TP183518 AND TP183519 SETS OF PARTS, TP182793 HEAT SINK PLATE
AND TP180000 CODE BAR BASKET

APPARATUS AFFECTED: 33A, 33A-1, 33A-2, 33A-3, 33A-4, 33B, 33C-1, 33C-2, 33C-3, 33C-4, 33C-5, 33D, 33D-1, 33D-2, 33D-3, 33D-4, 33E, 33F, 33F-1, 33F-2, 33F-3, and 33F-4 Teletypewriter-Sets.

OBJECT: To improve the operation of the teletypewriter-set by replacing and/or modifying old style parts.

SECTION 574-100-800.15

Fig. 1

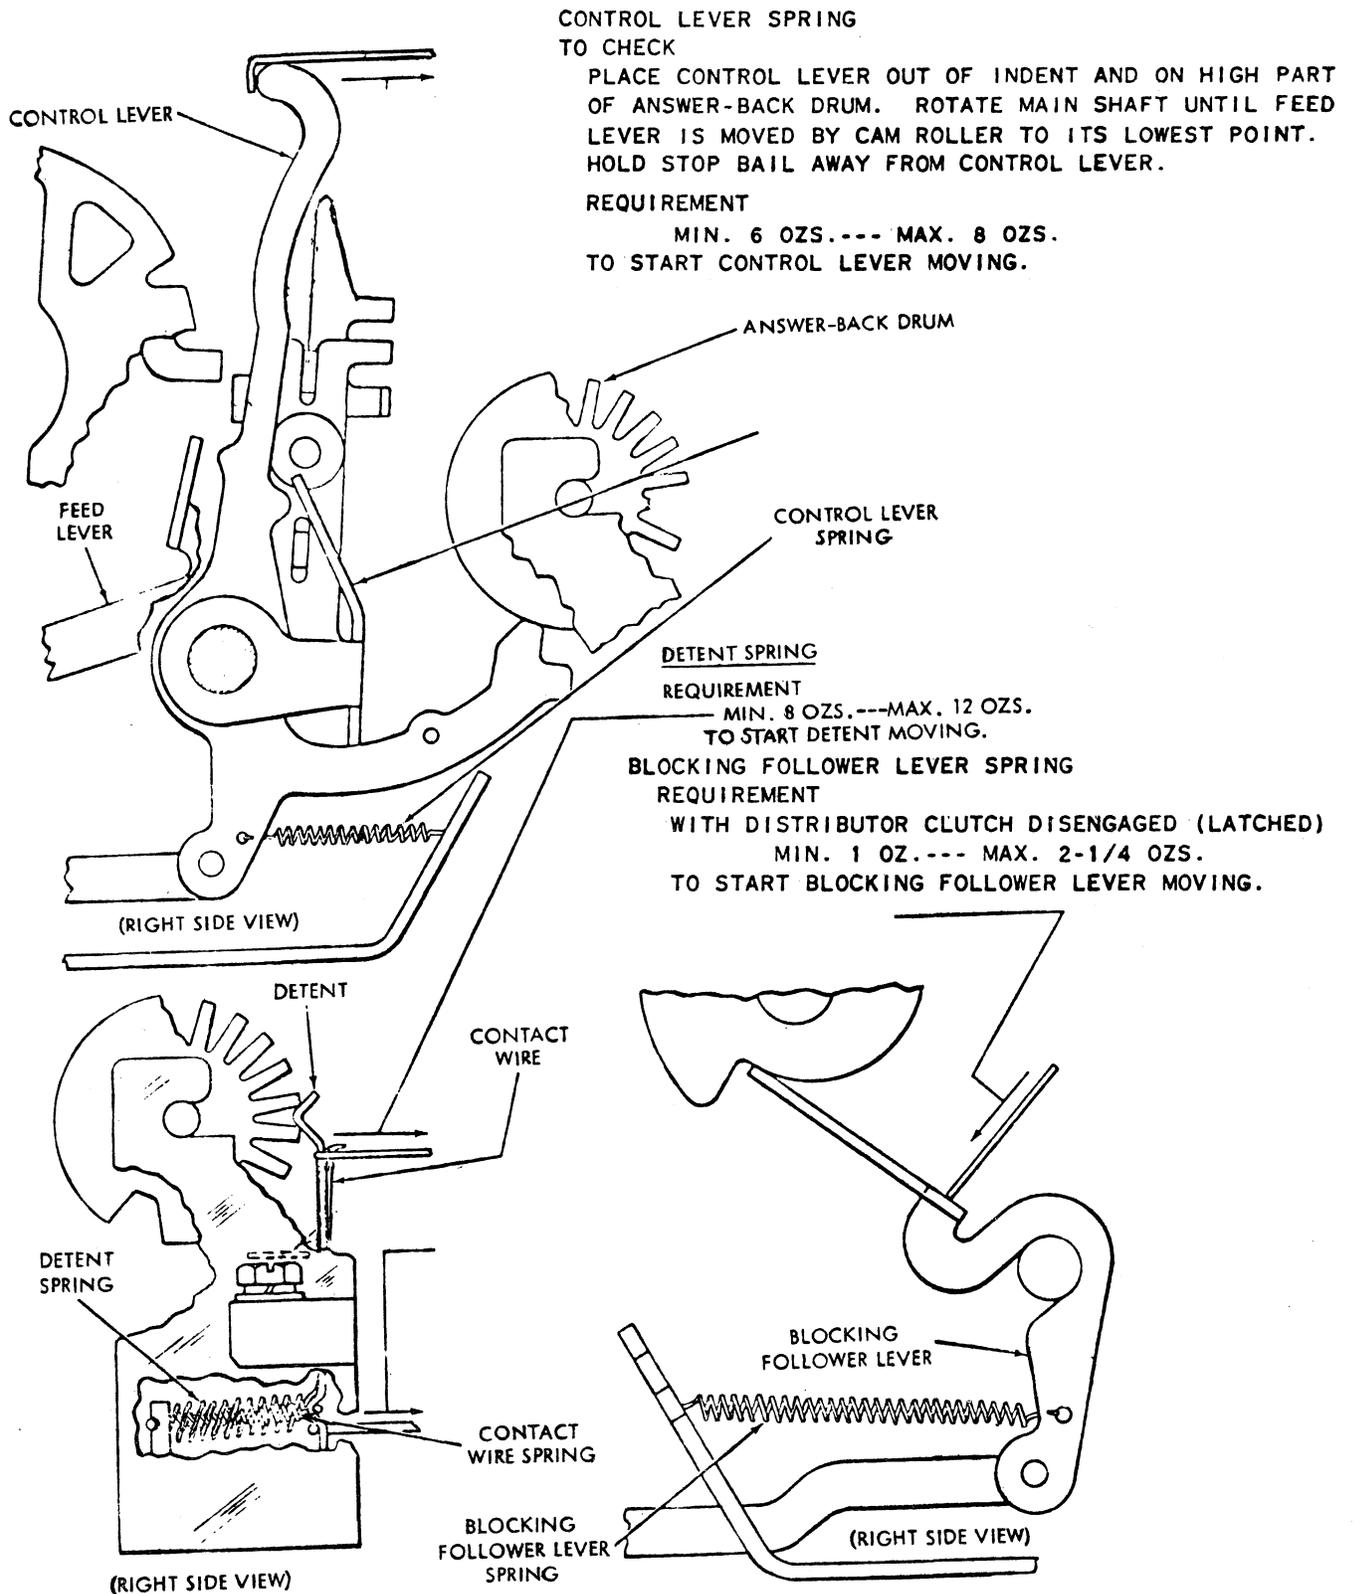
When the above new style or modified old style parts have been incorporated into the typing unit, the new requirements shown in the figures shall be used.

Fig. 2

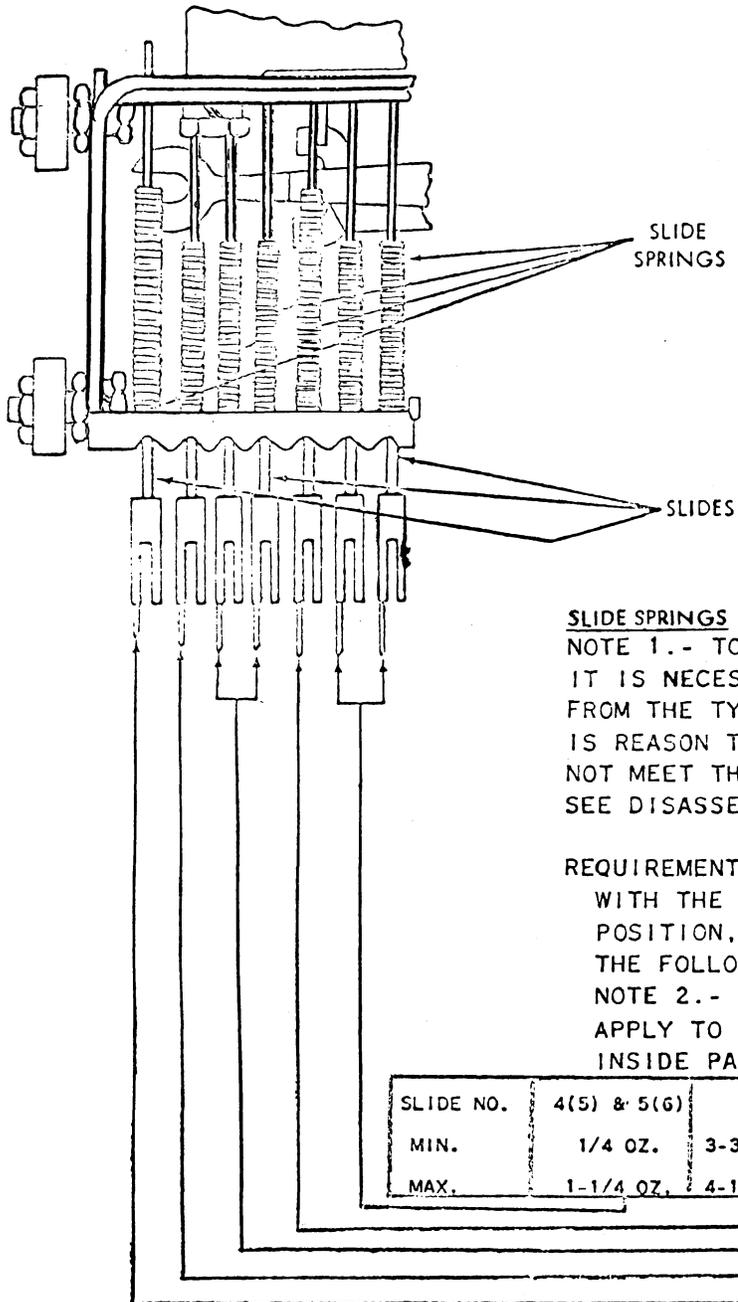
A TP81731 spring (25 turns of 0.012 wire — 39/64 inch long) replaces the TP180585 spring (41 turns of 0.009 wire — 5/8 inch long) (see page 2-7) (in the carriage lower plate mechanism) which hooks from the TP180512 slide to the TP180479 bracket.

TP180511 carriage stop slide (see page 2-7) (two required) has been redesigned and hardened to Rockwell C54-58. There are no apparent means of identifying new and old style slides.

WITH THE CARRIAGE POWER BAIL IN ITS STOP POSITION, TOWARDS THE FRONT, IT SHALL REQUIRE THE FOLLOWING TO START THE SLIDES MOVING.

SLIDE NO.	4(5) & 5(6)	3(4)	1(2) & 2(3)	0(1)	P.S.*
MIN.	1/4 OZ.	3-3/4 OZS.	2 OZS.	1/4 OZ.	3-3/4 OZS.
MAX.	1-1/4 OZ.	4-1/2 OZS.	3 OZS.	1 OZ.	4-1/2 OZS.

Fig. 3

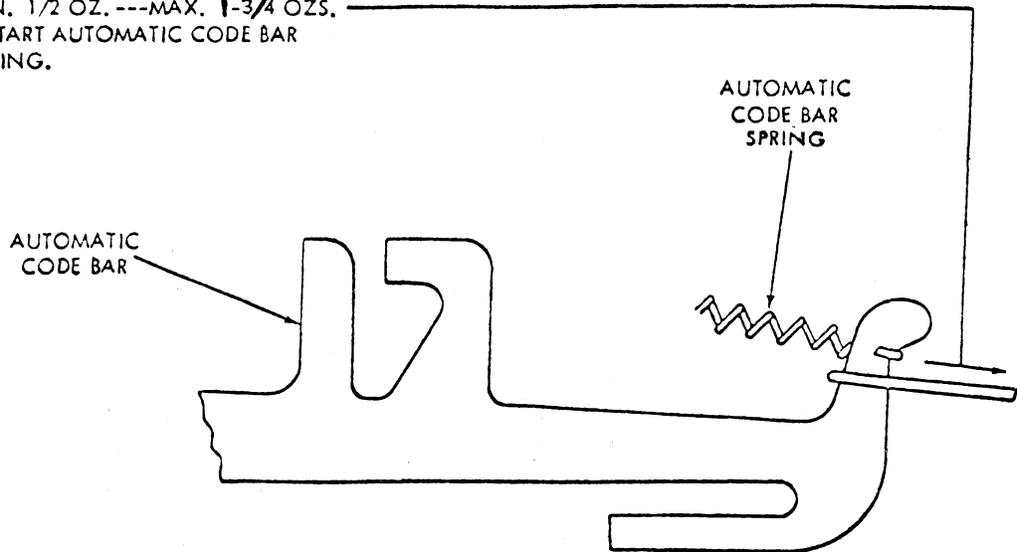
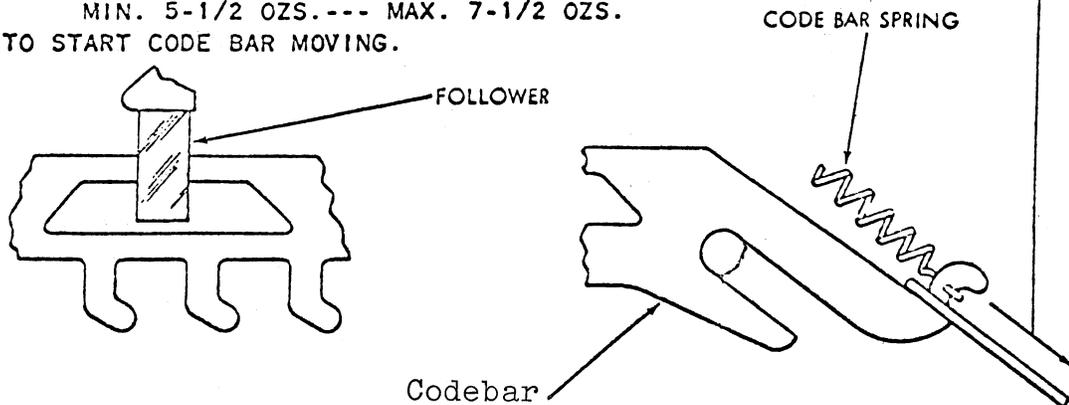
A TP180956 spring (39 turns of 0.015 wire — 13/16 inch long) replaces the TP180922 spring (48 turns of 0.013 wire — 7/8 inch long) (see page 2-11) which hooks from the TP180947 print suppression code bar to the TP180921 bracket.

WITH CARRIAGE AT LEFT MARGIN
 MIN. 1/2 OZ. --- MAX. 1-3/4 OZS.
 TO START AUTOMATIC CODE BAR
 MOVING.

MIN. 12 OZS. --- MAX. 14OZS.

MIN. 5-1/2 OZS. --- MAX. 7-1/2 OZS.

Fig. 4

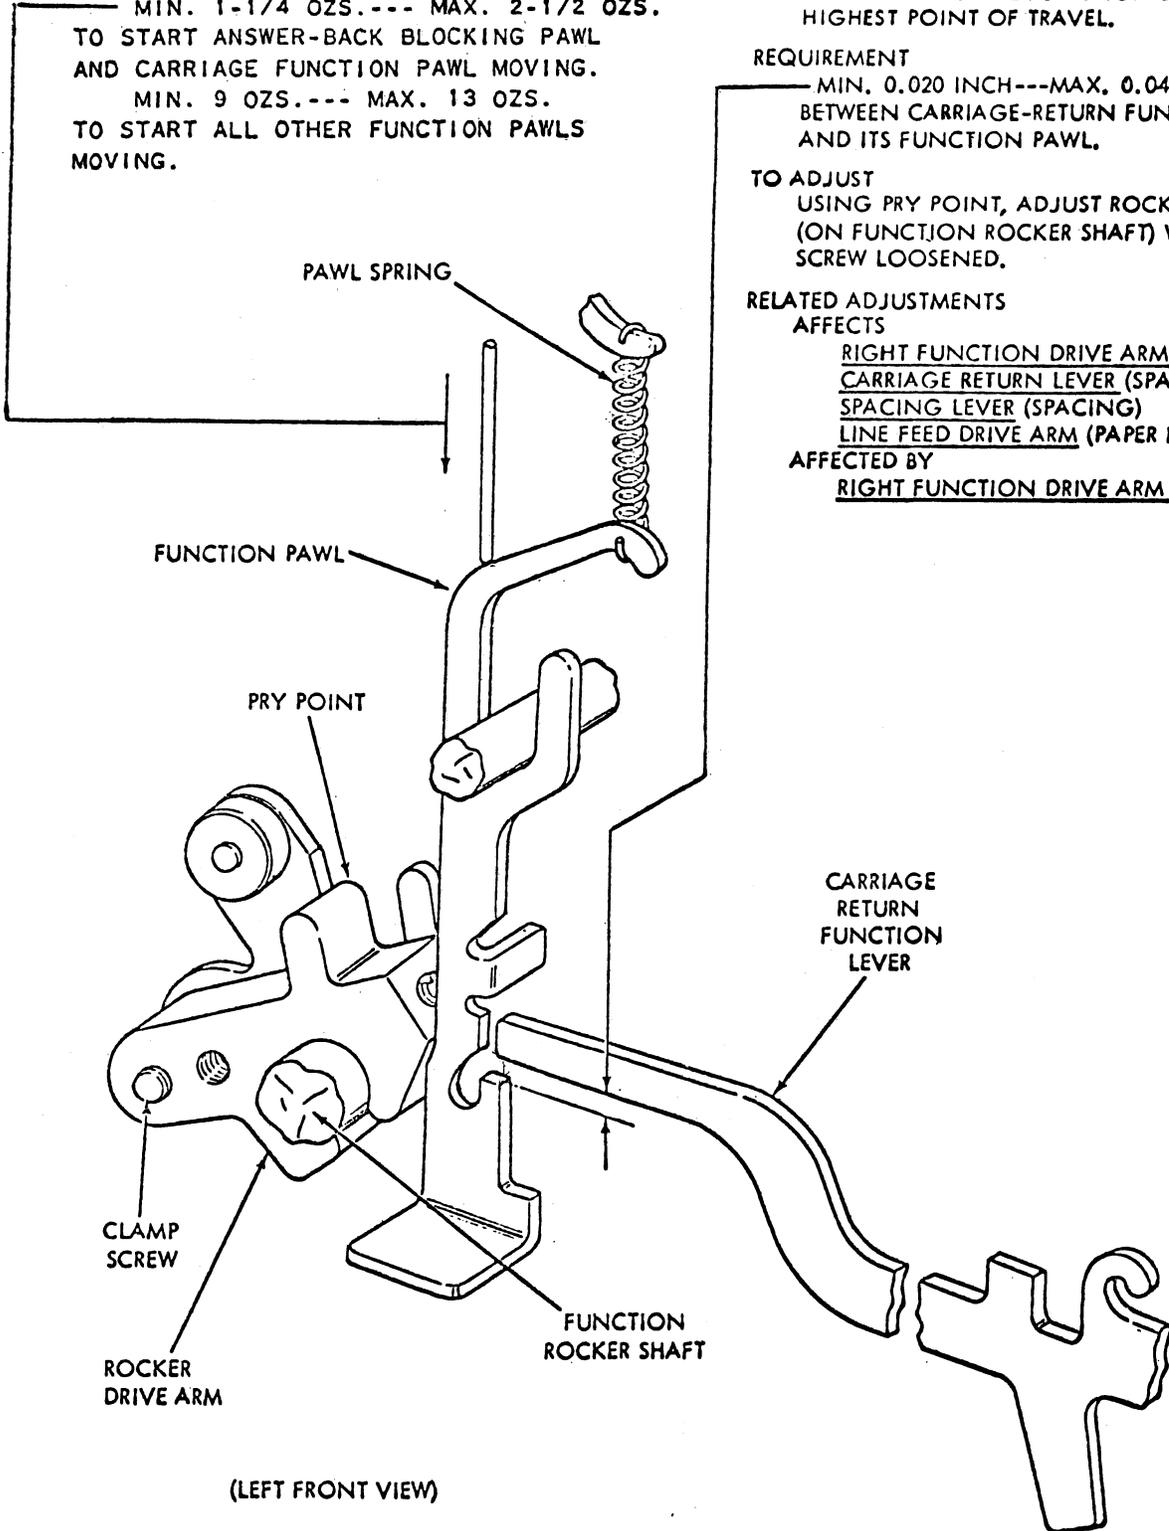
The TP49420 springs (26 turns of 0.016 wire — 0.0719 inch long) replace the TP86283 springs (38 turns of 0.012 wire — 0.075 inch long) (see page 2-13) associated with function pawls other than the answer-back blocking pawl and the carriage return function pawl.

The TP181322 carriage return function pawl (see page 2-13) has been modified, nickel-plated and hardened to Rockwell C43-48.

MIN. 1-1/4 OZS.--- MAX. 2-1/2 OZS.
TO START ANSWER-BACK BLOCKING PAWL AND CARRIAGE FUNCTION PAWL MOVING.
MIN. 9 OZS.--- MAX. 13 OZS.
TO START ALL OTHER FUNCTION PAWLS MOVING.

MIN. 0.020 INCH---MAX. 0.040 INCH BETWEEN CARRIAGE-RETURN FUNCTION LEVER AND ITS FUNCTION PAWL.

Fig. 5

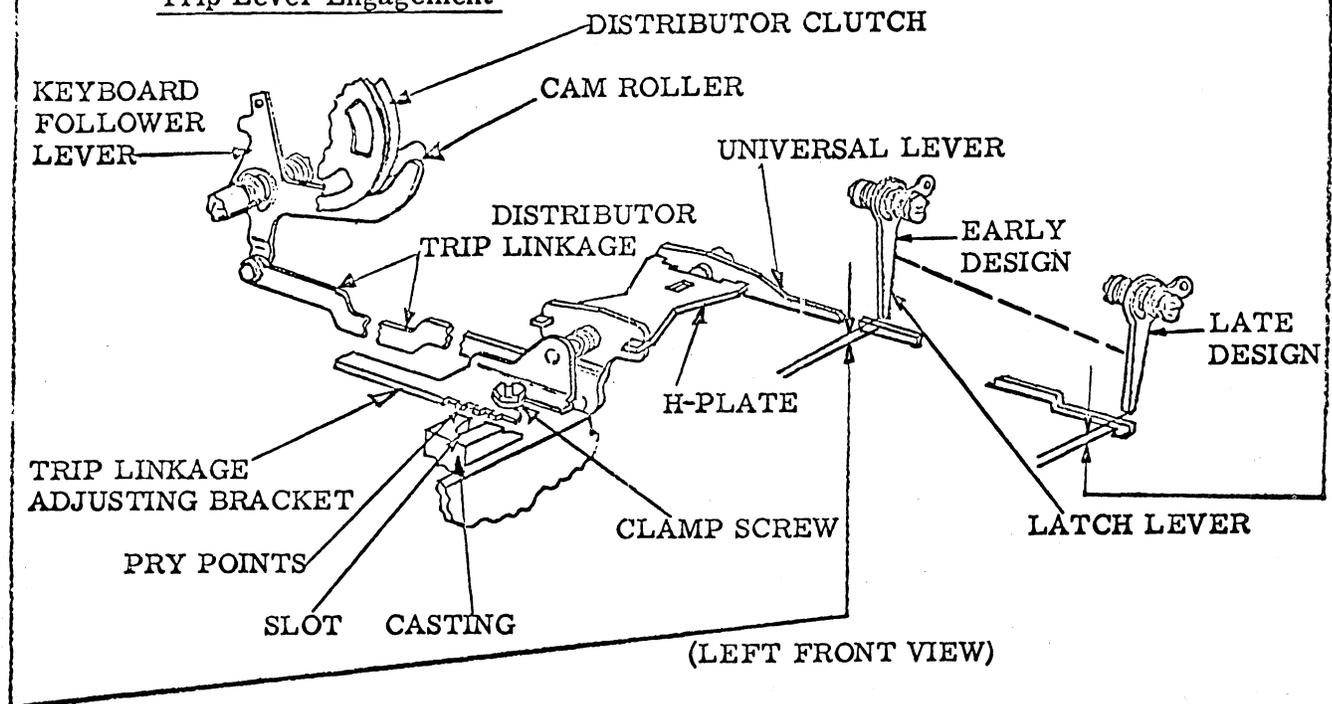
TP156740	Screw	
TP124177	Lock washer	
TP7002	Flat washer	
TP44048	Flat washer	
TP182244	Cam Follower Lever (nickel-plated)	— replaces TP180822 Lever (see page 2-17) (black oxide finish)
TP182239	Latch Lever (nickel-plated)	— replaces TP180030 Lever (see page 2-24) (black oxide finish)
TP182240	Trip Lever (has small tab)	— replaces TP180086 Lever (see page 4-2) (does not have tab)
TP182262	Trip Lever (nickel-plated)	— replaces TP180981 Arm (see page 2-17) (black oxide finish)

Early design keyboards with universal lever 180086 :

Min. 0.010 inch---Max. 0.035 inch
between latch lever and universal lever.

Late design keyboards with universal lever 182240 :

Min. 0.010 inch---Max. 0.040 inch
between latch lever and universal lever.

Fig. 6

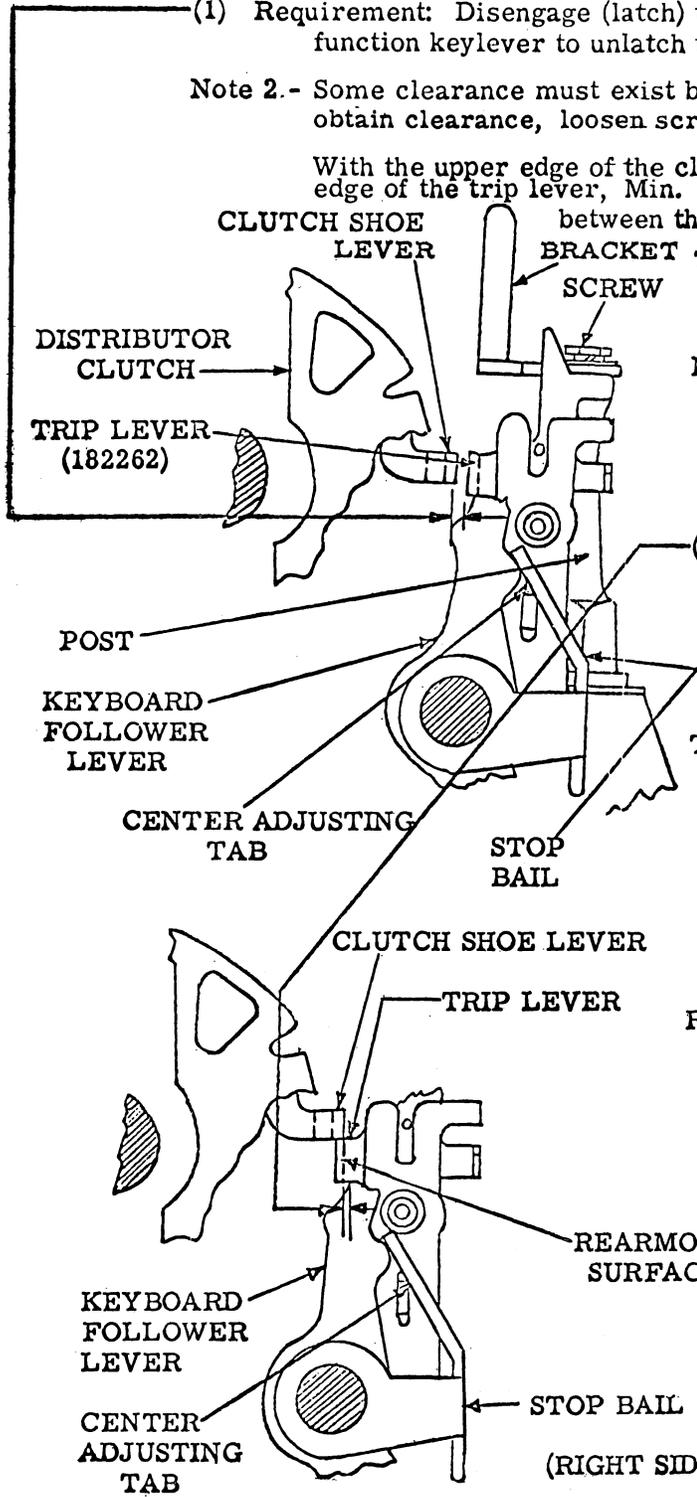
A TP182276 trip lever (nickel-plated) replaces the TP180843 trip lever (black oxide finish) (see page 2-22) in the answer-back trip magnet mechanism.

Note 1 - Requirement (1) applies only to printers of late design equipped with the 182262 trip lever.

With the upper edge of the clutch shoe lever in line with the upper edge of the trip lever, Min. 0.015 inch---Max. 0.035 inch, clearance between the clutch shoe lever and the trip lever.

(2) Requirement: With the printer operating under power and the keyboard universal lever in the latched position, the clutch shoe lever shall be Min. flush---Max. 0.015 inch beyond the rearmost surface of the trip lever.

To Adjust: Late design printers with the 182262 trip lever, with screw loosened friction tight, position bracket.

Early design printers without the 182262 trip lever, remove answer-back drum. Bend center adjusting tab with bending tool 180993. See note 3 above. Replace answer-back drum.

Fig. 8

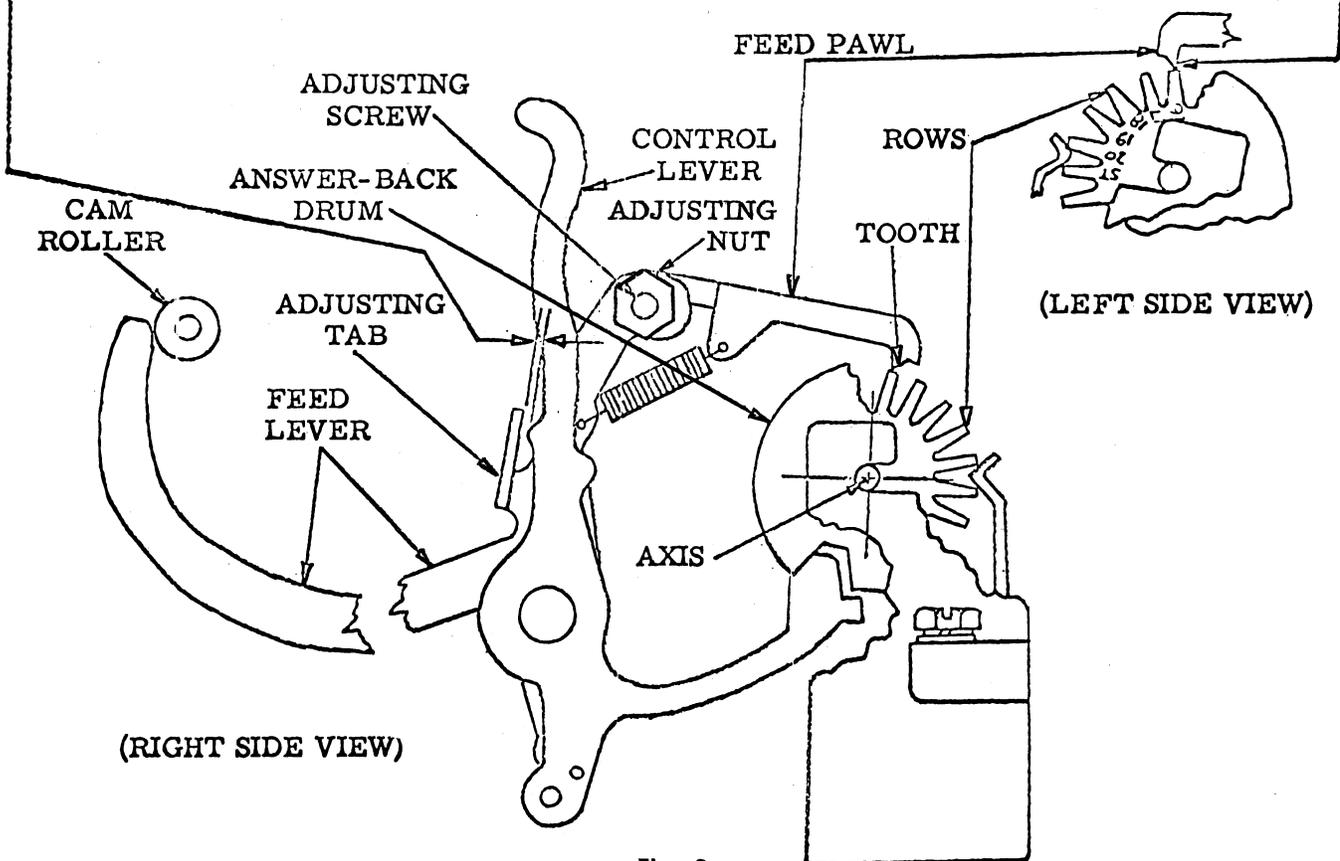
The TP180828 feed pawl (see page 2-17) (in the trip shaft mechanism) has been modified by reducing the over-all length by .005 inch.

Requirement: Feed pawl tooth to rest on rear half of the top of row "16" of answer-back drum feed ratchet.

To Adjust: With feed pawl adjusting nut and screw friction tight, position feed pawl.
